Access Compliance Report

Public Rights-of-Way

Intersection ID: 10041968	Main Street: WINDSOR_CASTLE_LN	Cross Street: N/A	Location:	S
ADA ID: 8C3D8FB5C4B6	Ramp Type: PerpDiag	Initial Pass/Fail: Fail	Overall Compliance: No	Severity Score: 50
Codes/Mitigation Info/Possible Solution		Field Measurements/Component Compliance

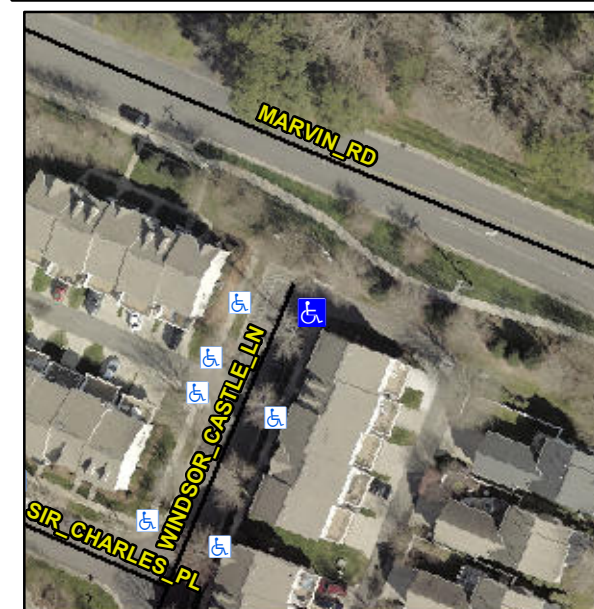
R304.2.2, R304.5.3

Compliance	Description	Data	Compliance	Description	Data
N/A	Ramp Length (in)	76.0	No	Ramp Slope (%)	12.0
Yes	Ramp Width (in)	48.0	No	Ramp XSlope (%)	7.8
N/A	Flare Type LT	N/A	N/A	Flare Type RT	N/A
N/A	Flare Slope LT (%)	N/A	N/A	Flare Slope RT (%)	N/A
N/A	Flare Traversable LT?	N/A	N/A	Flare Traversable RT?	N/A
N/A	Landing Length (in)	N/A	N/A	DWS Provided?	N/A
N/A	Landing Width (in)	N/A	N/A	DWS Contrast?	N/A
N/A	Landing Slope (%)	N/A	N/A	DWS Length (in)	N/A
N/A	Landing X Slope (%)	N/A	N/A	DWS Full Width?	N/A
N/A	Landing Curb? (Y/N)	N/A	N/A	DWS Offset (in)	N/A
N/A	Shared Landing?	N/A			
N/A	Gutter Ponding?	N/A	N/A	Gutter Slope (%)	N/A
N/A	Gutter Lip Ht (in)	N/A	N/A	Gutter X Slope (%)	N/A
N/A	Painted X Walk1?	No	N/A	Painted X Walk2?	No
	X Walk 1 Direction	To N		X Walk 2 Direction	To W
N/A	X Walk 1 Width (in)	N/A	N/A	X Walk 2 Width (in)	N/A
	X Walk 1 Slope (%)	2.4		X Walk 2 Slope (%)	1.0
	X Walk 1 X Slope (%)	2.0		X Walk 2 X Slope (%)	3.1

Remove & Replace Curb Ramp With Two New Directional Ramps or Equivalent.
